**This letter serves as an objection to the public notification of the Mountain Cement permit #298C-A8.**

1. Removal of rock outcrops in Pit 1.
2. Restoration seed mix failing to guarantee the minimal amounts of sagebrush seed to be planted to restore wildlife habitat to post mine land use levels and concerns with mountain mahogany restoration.
3. Safety concerns.
4. Not following previously approved mining conditions.

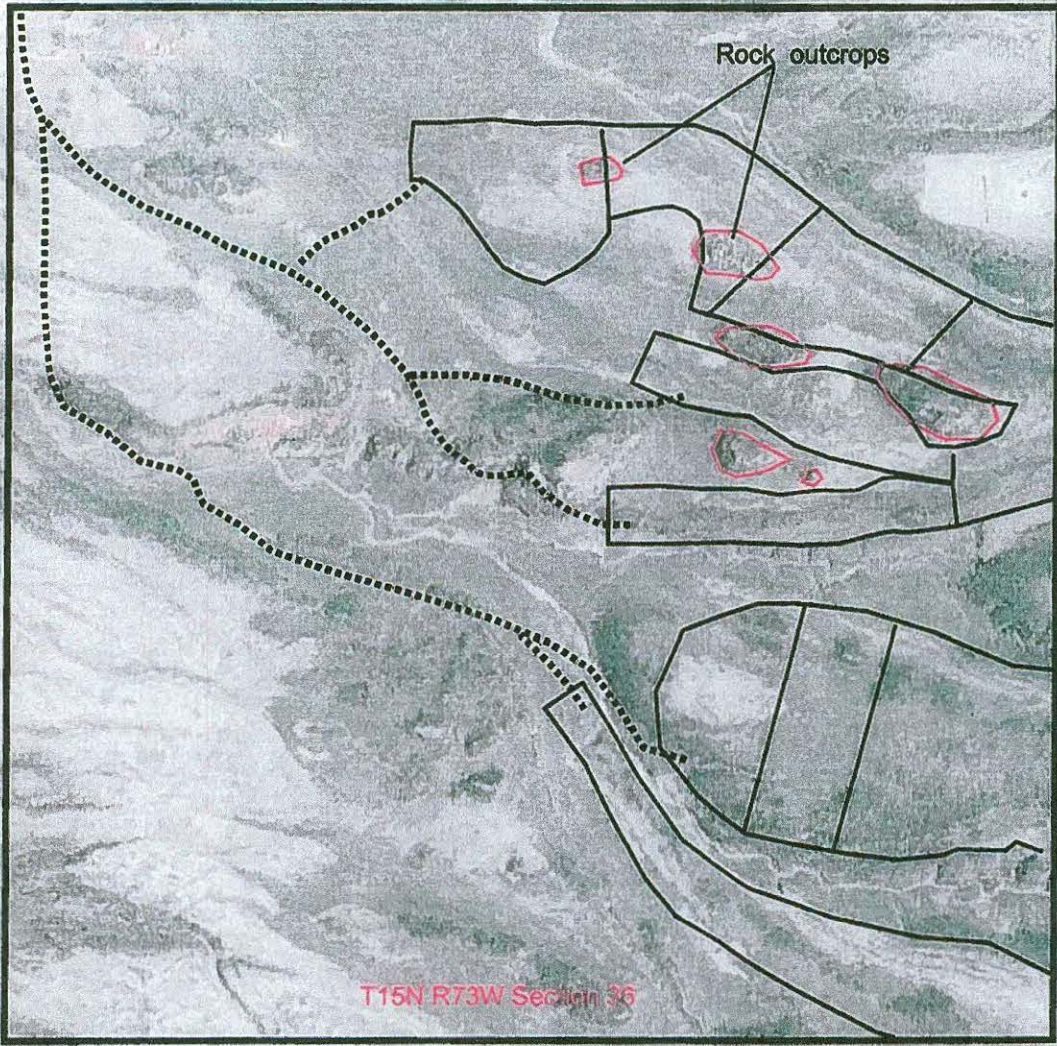
The proposed mine plan for section 36 appears to indicate that Pit 1 will mine through two rock outcrops. These rock outcrops appear to be in the years 1-3 of the mine plan for Pit 1 (See attached map). The larger of these outcrops measure 320 by 160 ft and is over 3 meters tall. The second rock outcrop measures 200 by 100 ft. As stated above the outcrops are locations of mountain mahogany noted in many places in the MCC permit application as an important species and given its own classification in Appendix DIX8 Vegetation Inventory, listed as MM-Mountain Mahogany Shrubland (DIX8-3). Mountain Mahogany was noted as important to wildlife. "Reclamation will include Mountain Mahogany in those areas where shrubs existed prior to mining (DIX9-15). The Wyoming Game and Fish also note the importance of Mountain Mahogany (DIX9-5).

MCC notes that rock outcrops occur within the proposed mine areas. "To further avoid becoming a public nuisance MCC will not disturb the red sandstone monoliths and outcrops that are present in Section 36.....Mountain Cement reserves the right to disturb monoliths and outcrops that fall within the mining blocks but may decide to mine around them leaving them undisturbed." (MPIX-23). MCC should fulfill their verbal contract with the residents of Summit Estates and also protect unique wildlife habitats and occurrences of Mountain Mahogany by stating MCC will not mine through the rock outcrops in Pit 1 located in T15N, R73W, Section 36.
